RHODE ISLAND CONTRACT NO.2020-CB-015

Bridge Group 10 - I-295

NOTICE TO PROSPECTIVE BIDDERS

ADDENDUM NO. 3 Prospective bidders and all concerned are hereby notified of the following changes in the Plans, Specifications, Proposal and Distribution of Quantities for this contract. These changes shall be incorporated in the Plans, Specifications, Proposal and Distribution of Quantities, and shall become an integral part of the Contract Documents.

<p>Gordon R. Archibald, Inc. Civil and Environmental Engineers</p>	<p>TITLE OF SKETCH</p> <p>BRIDGE GROUP 10 - I-295 FARNUM PIKE BRIDGE NOS. 074301 & 074321</p> <p>JOINT DETAILS - 1</p>	<p>RI CONTRACT NO. 2020-CB-015</p>
	<p>DATE: 5/1/2020</p>	<p>ADDENDUM NUMBER 3</p>
<p>REVISION TO SHEET NO. 27</p>

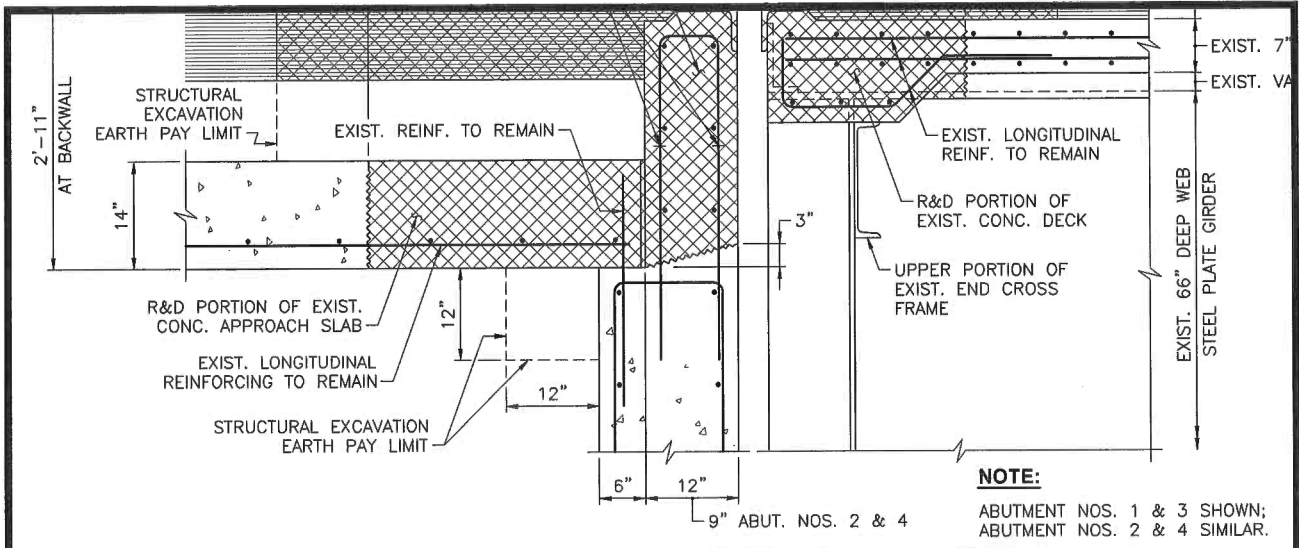
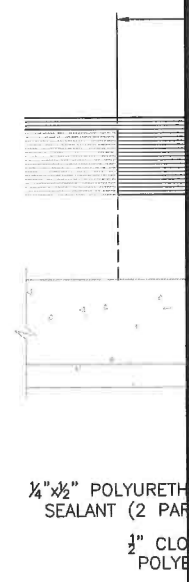
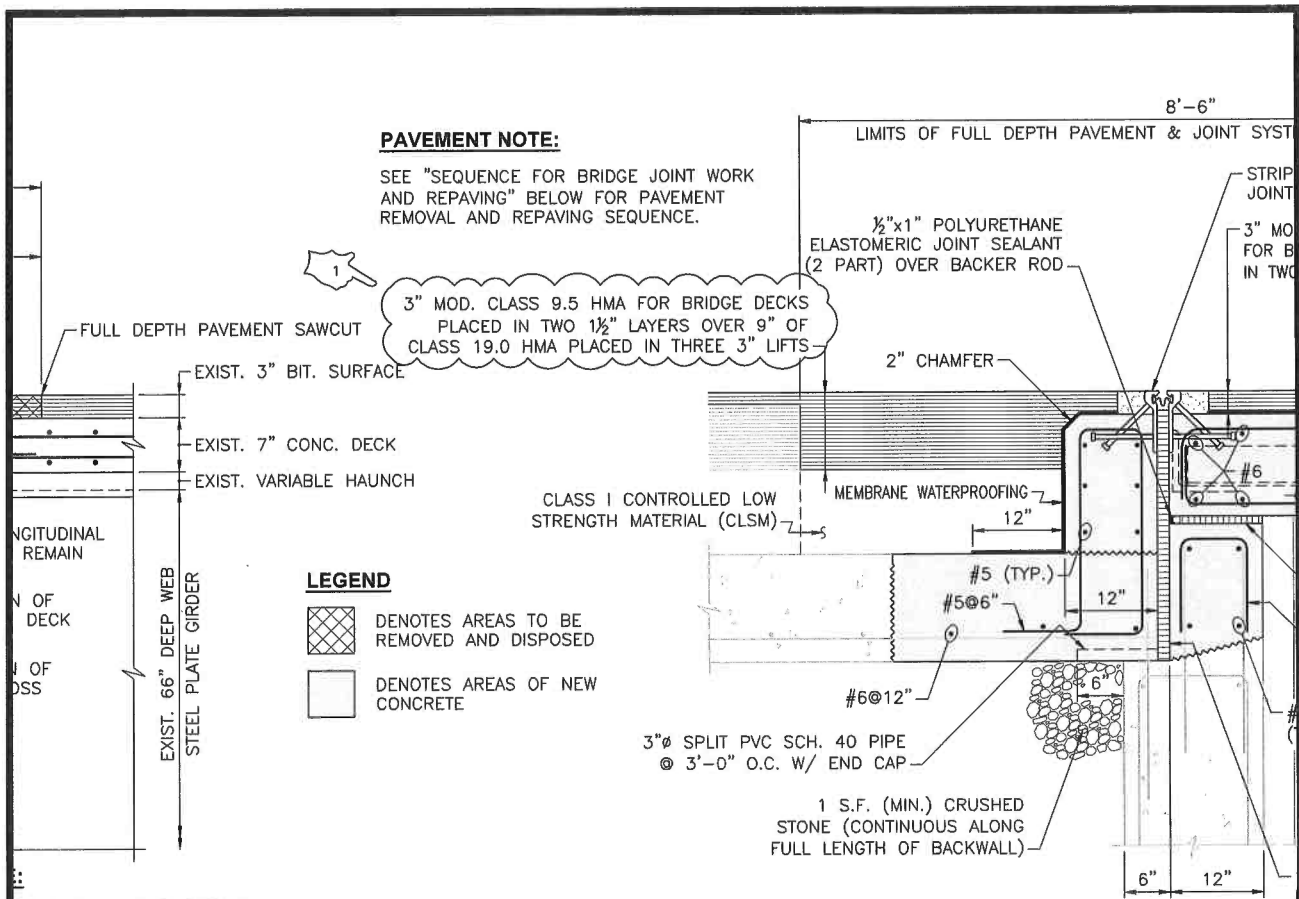
6. Sheet No. 27 - Farnum Pike Bridge Nos. 074301 & 074321 - Joint Details - 1
Revise Sheet No. 27 as shown on Sketch Nos. 11(R-1) and 12(R-1) attached to this Addendum No. 3. Sequence for Bridge Joint Work and Repaving Note No. 4 has been revised and the pavement structure at approaches has been changed.

1. REMOVE AND DISPOSE MATERIALS AS CALLED FOR IN THE DETAILS.
2. RECONSTRUCT APPROACH SLAB, WITH NEW HAUNCH, BACKWALL, WINGWALL, DECK OVER BACKWALL, AND BARRIERS, AS CALLED FOR IN THE DETAILS; SET STRIP SEAL EXPANSION JOINT SYSTEM AT ELEVATION OF PROPOSED ROADWAY AT ABUTMENT NOS. 1 & 3.
3. INSTALL NEW WATERPROOFING MEMBRANE AND REPAVE (FULL DEPTH).
4. AFTER FULL WIDTH OF BRIDGE JOINT WORK HAS BEEN COMPLETED, REMOVE 1½" DEPTH OF PAVEMENT ON THE BRIDGE AND APPROACHES, CLEAN & SWEEP THE SURFACE, APPLY TACK COAT, AND PAVE ENTIRE SURFACE WITH 1½" DEPTH OF MOD. CLASS 9.5 HOT MIX ASPHALT FOR BRIDGE DECKS.
5. AT ABUTMENT NOS. 2 & 4, SAWCUT & SEAL JOINT.

Gordon R. Archibald, Inc. Civil and Environmental Engineers	TITLE OF SKETCH BRIDGE GROUP 10 - I-295 FARNUM PIKE BRIDGE NOS. 074301 & 074321 JOINT DETAILS - 1	RI CONTRACT NO. 2020-CB-015
	SKETCH NO. 12	
DATE: 5/1/2020	ADDENDUM NUMBER 3	REVISION TO SHEET NO. 27

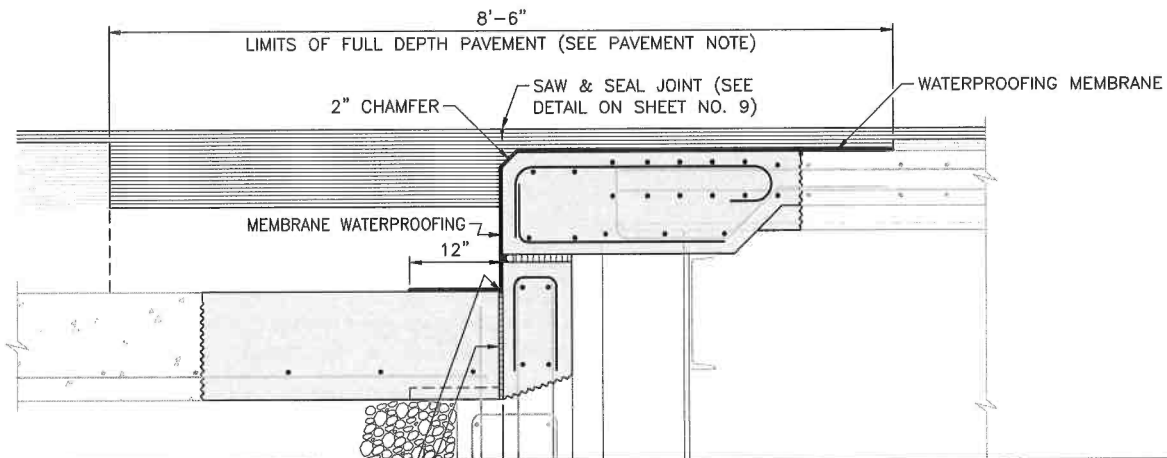
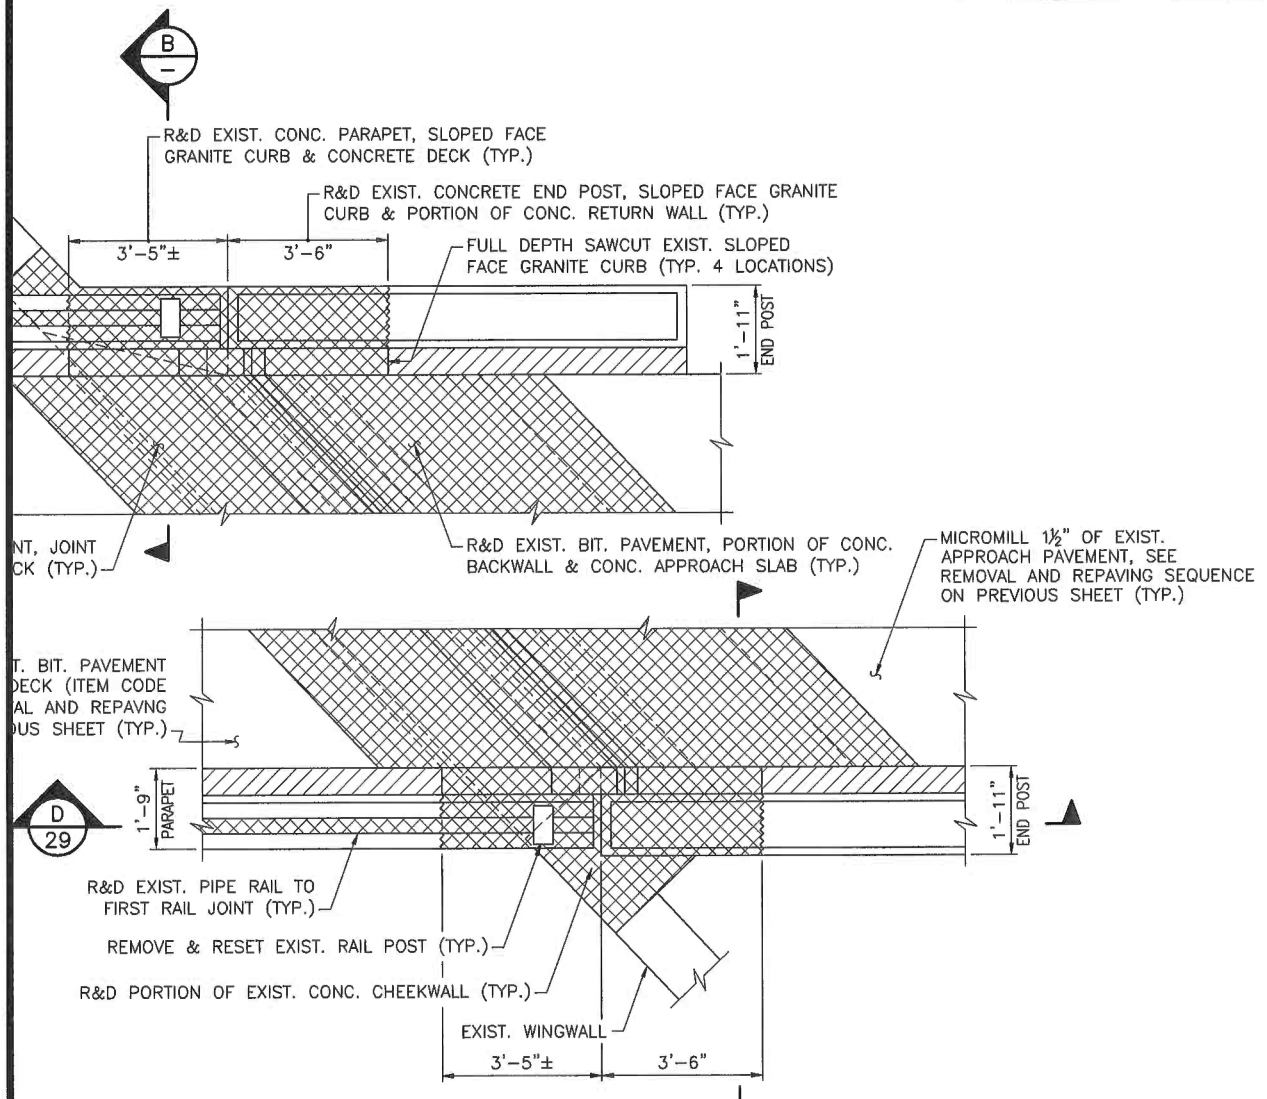
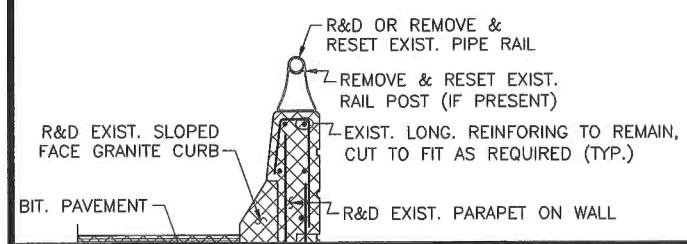
7. Sheet No. 28 - Farnum Pike Bridge Nos. 074301 & 074321 - Joint Details - 2
Revise Sheet No. 28 as shown on Sketch No. 13(R-1) attached to this Addendum No. 3. A note has been added regarding payment for the full depth sawcut of granite curb.

NOTE:
THE COST OF THE FULL DEPTH SAWCUT OF GRANITE CURB SHALL BE CONSIDERED INCIDENTAL TO ITEM CODE 803.0300.

<p>Gordon R. Archibald, Inc. Civil and Environmental Engineers</p>	<p>TITLE OF SKETCH</p> <p>BRIDGE GROUP 10 - I-295 FARNUM PIKE BRIDGE NOS. 074301 & 074321</p> <p>JOINT DETAILS - 2</p>	<p>RI CONTRACT NO. 2020-CB-015</p>
	<p>DATE: 5/1/2020</p>	<p>ADDENDUM NUMBER 3</p>
<p>REVISION TO SHEET NO. 28</p>

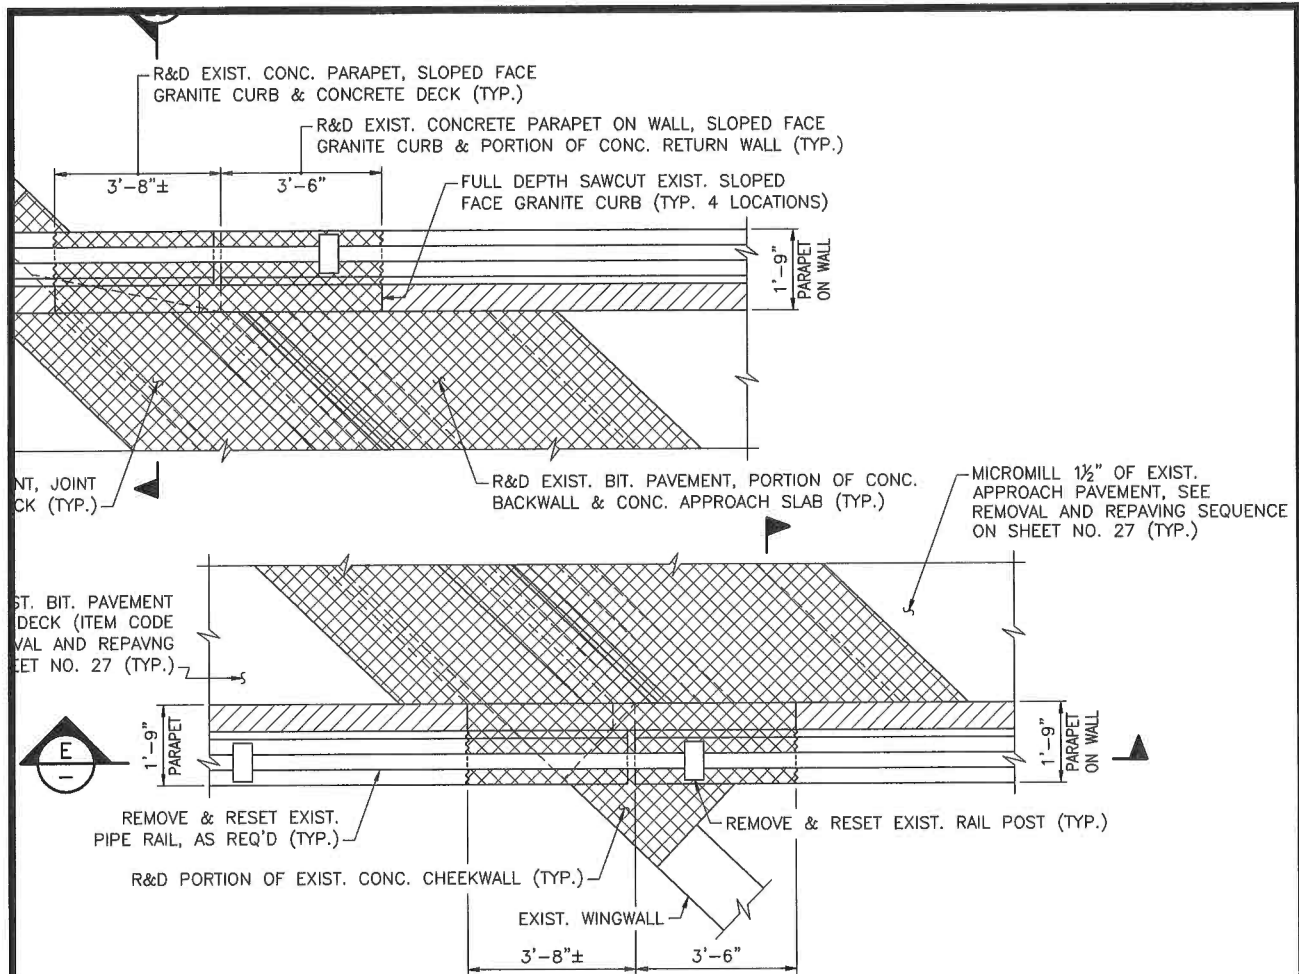
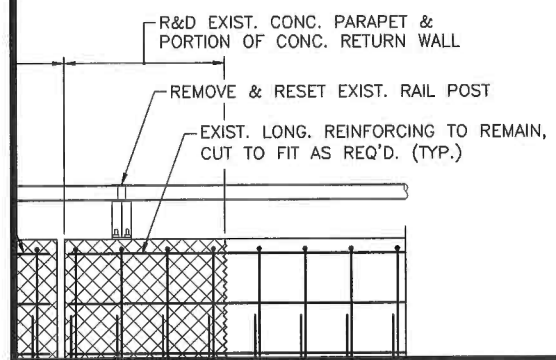
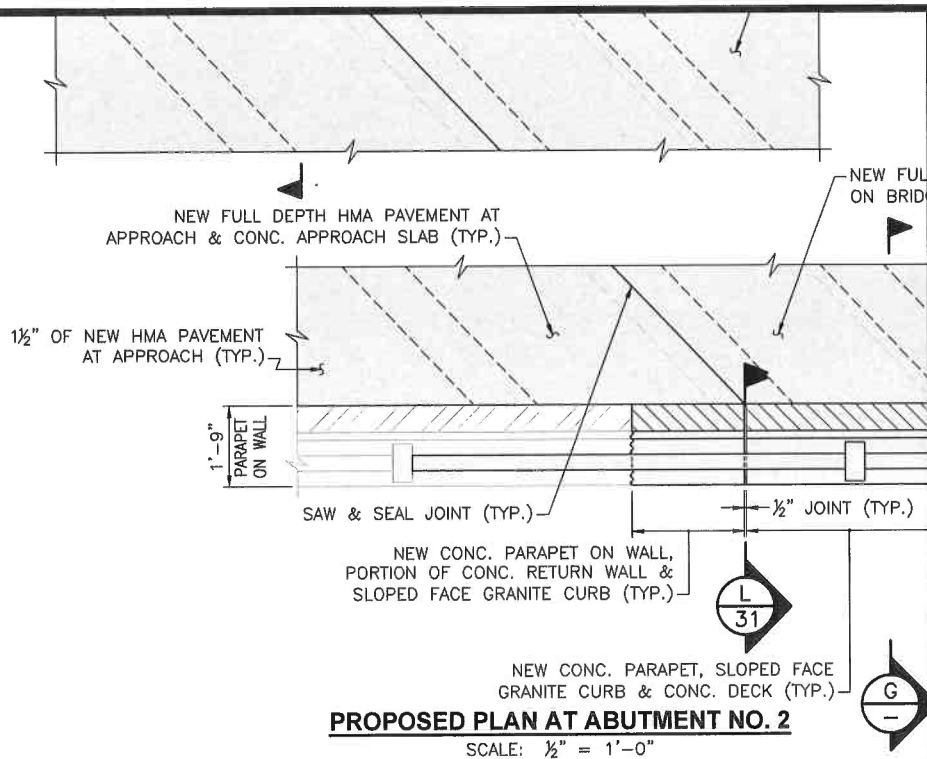
8. Sheet No. 29 - Farnum Pike Bridge Nos. 074301 & 074321 - Joint Details - 3
Revise Sheet No. 29 as shown on Sketch No. 14(R-1) attached to this Addendum No. 3. A note has been added regarding payment for the full depth sawcut of granite curb.

NOTE:
 THE COST OF THE FULL DEPTH SAWCUT OF GRANITE CURB SHALL BE CONSIDERED INCIDENTAL TO ITEM CODE 803.0300.

TITLE OF SKETCH
BRIDGE GROUP 10 - I-295
FARNUM PIKE BRIDGE NOS. 074301 & 074321
JOINT DETAILS - 4

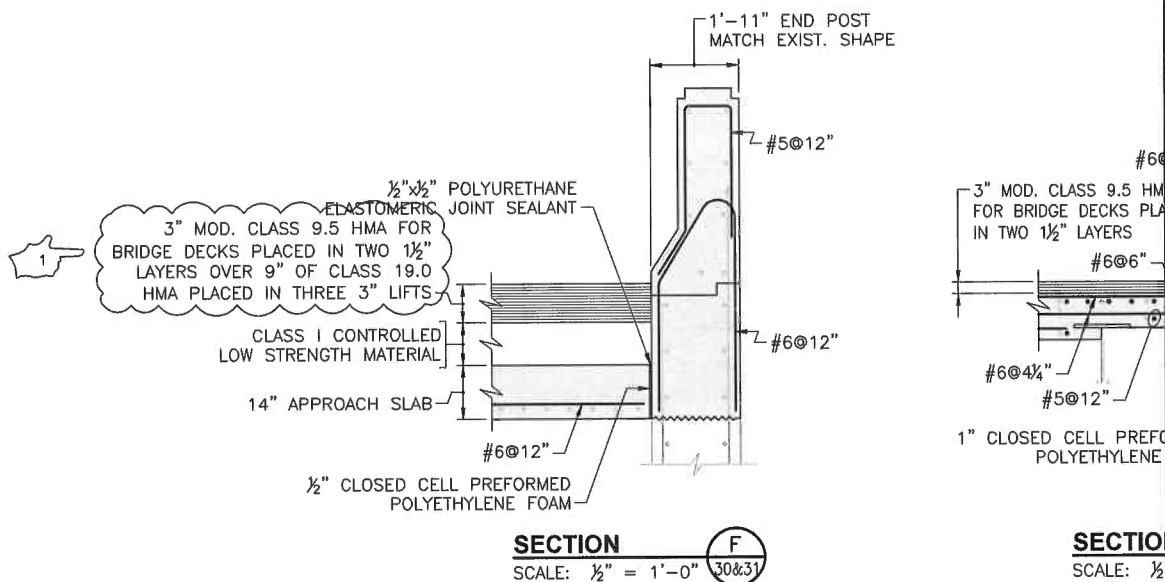
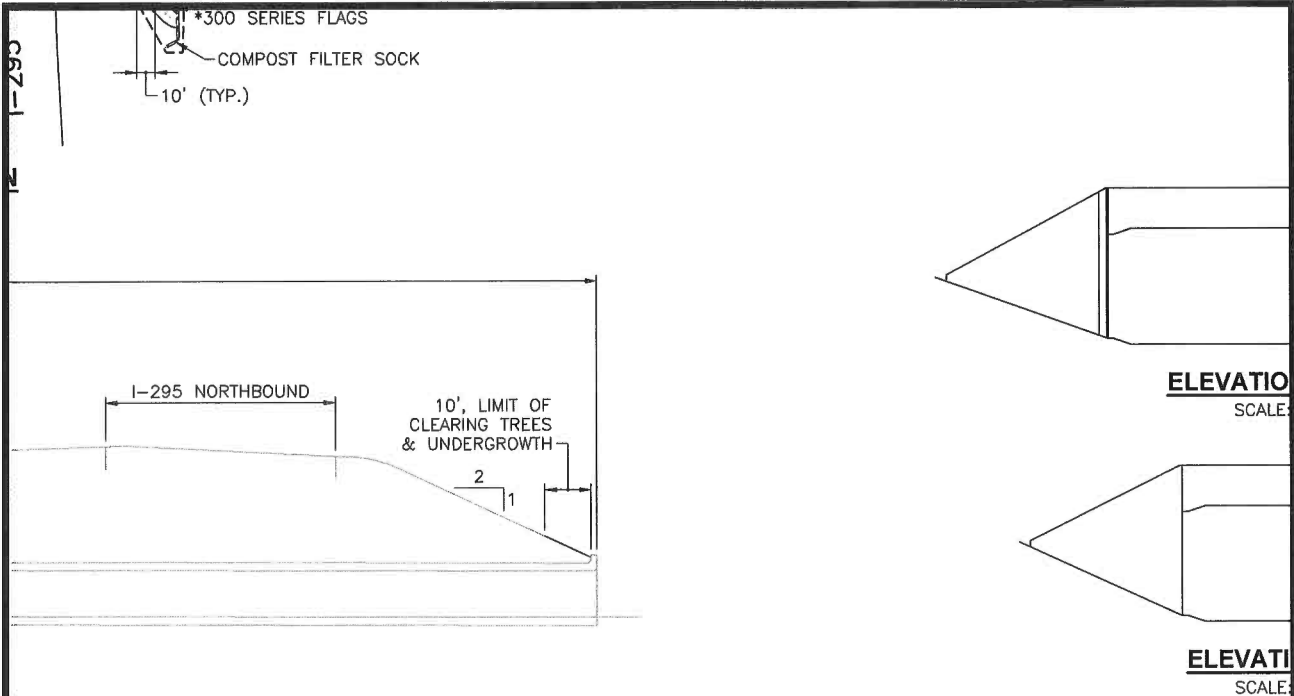
9. Sheet No. 30 - Farnum Pike Bridge Nos. 074301 & 074321 - Joint Details - 4
Revise Sheet No. 30 as shown on Sketch No. 15(R-1) attached to this Addendum No. 3. The pavement structure at approaches has been changed.

SKETCH NO.
21

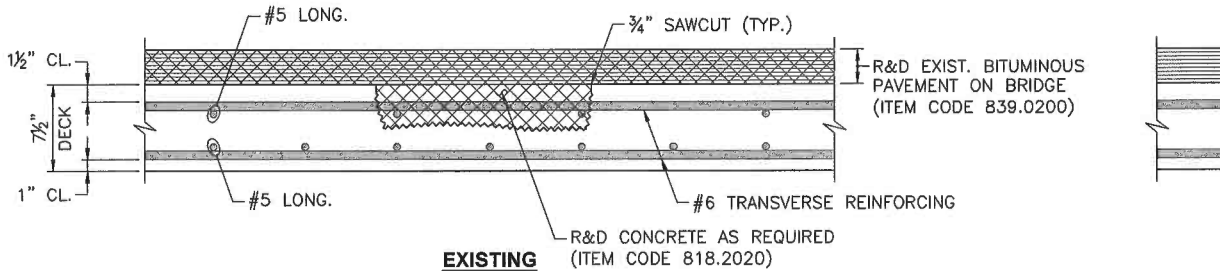
15. Sheet No. 51 - George Washington Highway Bridge No. 074701 - Substructure Repairs - 3
Revise Sheet No. 51 as shown on Sketch Nos. 21(R-1) attached to this Addendum No. 3. Note No. 4 has been added regarding galvanic anodes not being required for pier column concrete repairs.

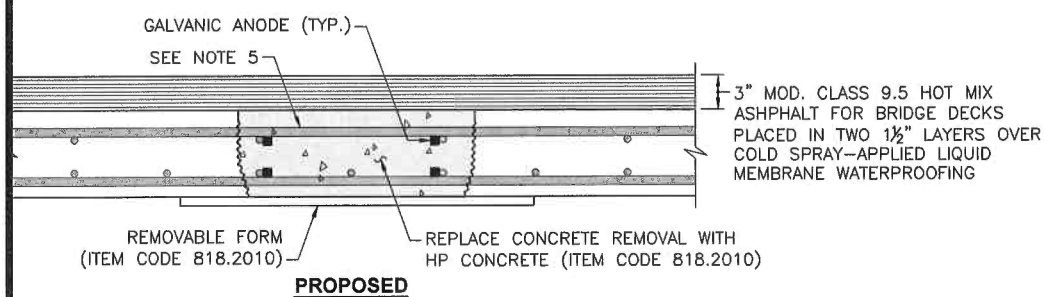
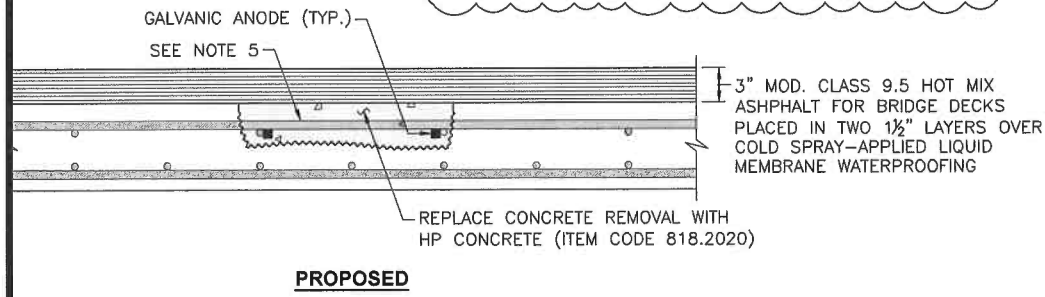
16. Sheet No. 56 - George Washington Highway Bridge No. 074701 - Bridge Deck Repair Details
Revise Sheet No. 56 as shown on Sketch Nos. 22(R-1) and 23(R-1) attached to this Addendum No. 3. Bridge Deck Repair Note No. 6 has been revised and a note regarding spacing of the galvanic anodes has been added.

GALVANIC ANODES SHALL BE SPACED EVENLY AROUND THE PERIMETER OF THE REPAIR AREA AT A MAXIMUM SPACING OF 18\"/>
